SUBDIVISION, PLANNED UNIT DEVELOPMENT, PLANNING APPROVAL, ZONING AMENDMENT, & SIDEWALK WAIVER REQUEST

STAFF REPORT Date: February 17, 2010

SUBDIVISION NAME Whisper Oak Subdivision

DEVELOPMENT NAME Whisper Oak Mobile Home Park

SITE PLAN

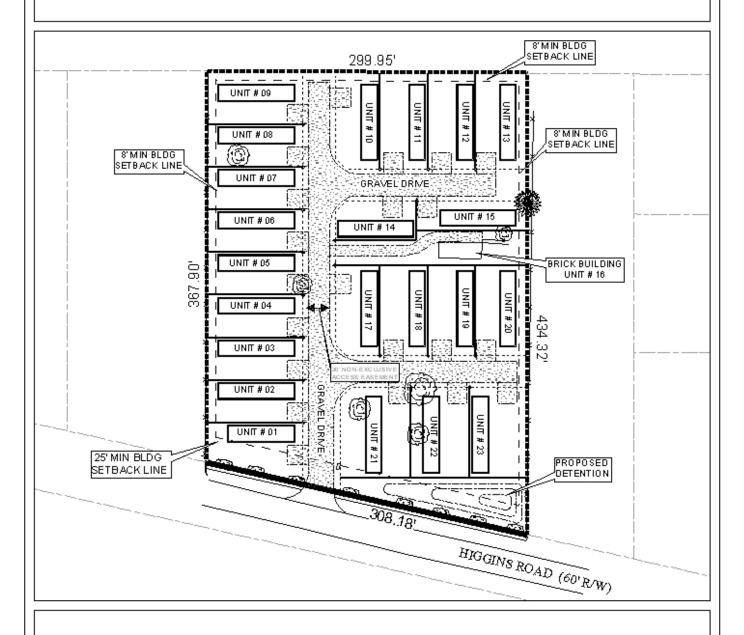
Regarding the lot layouts, Lots 1 and 21 appear to show the mobile home location area partially within the 25-foot minimum building setback line. No part of the mobile home location area should be located within the building setback. Also, regarding the size of each mobile home lot, Section 37-53 of the Mobile City Code requires a minimum lot size of 3,200 square feet for each mobile home lot. Area sizes for the lots are not shown, however, it appears that some lots may not meet this requirement. As such, each lot's size should be depicted to ensure that each meets the minimum size requirement.

Regarding access, the site plan depicts access as being via 20-foot wide gravel drives. The minimum size for two way accessways is 24 feet in width, and all accessways must be paved with asphalt or concrete. Additionally, parking of a sufficient number is depicted, however, the parking is depicted as being gravel; this should be revised to show the parking as asphalt or concrete.

The site plan is depicting an 8-foot setback to the East. The property to the East is developed as and zoned Single-Family Residential. As such, a 10-foot setback would be required to comply with buffering requirements. Additionally, no buffer is depicted, and, at a minimum, a privacy fence compliant with Section 64-4.D.1. should be provided.

It should be noted that Chapter 37 of the Mobile City Code sets out several design requirements for mobile home parks, and, as this application proposes substantial changes to the site, the provisions of Chapter 37 apply. Specifically, the site plan needs to show the following:

- Section 37-56: a playground common area surrounded by a fence or a wall of at least 4 feet in height containing 150 square feet for each mobile home lot
- Section 37-57: a dedicated patio area of at least 180 square feet on each lot, surfaced with rigid impervious pavement

The site plan does not indicate compliance with the tree and landscaping requirements of the zoning ordinance. Full compliance should be required.

- 1) revision of the site plan to remove all mobile home sites from the 25-foot minimum building setback line;
- 2) revision of the site plan to depict all two way accessways as being at least 24 feet in width:

- 3) revision of the site plan to depict all accessways and parking as either asphalt or concrete;
- 4) revision of the site plan, and redesign, as necessary, to depict all mobile lots as being at least 3,200 square feet in area;

- 5) revision of the site plan to depict the required playground/common area as required in Section 37-56 of the Mobile City Code;
- 6) revision of the site plan to depict the dedicated patio area as required in Section 37-57 of the Mobile City Code;

- 7) revision of the site plan to depict the 10-foot required setback and buffer area where the site abuts residentially zoned property as well as a privacy fence in compliance with Section 64-4.D.1. of the Zoning Ordinance; and

- 8) submittal of a landscape plan showing full compliance with the tree planting and landscaping area requirements of the Zoning Ordinance.

TYPICAL SECTION IN FRONT OF PROPERTY

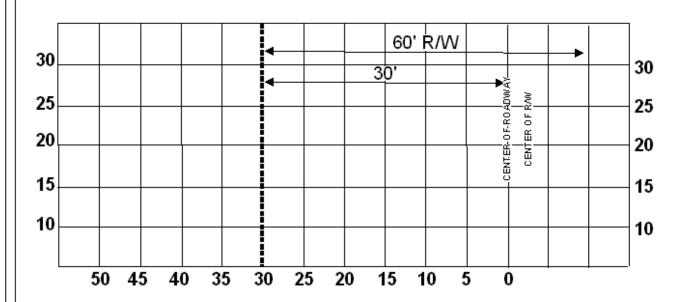
Lastly, regarding the sidewalk waiver request, city engineering has determined that construction of a sidewalk is not practical due to open drainage and insufficient right-of-way. As such, the sidewalk waiver should be approved.
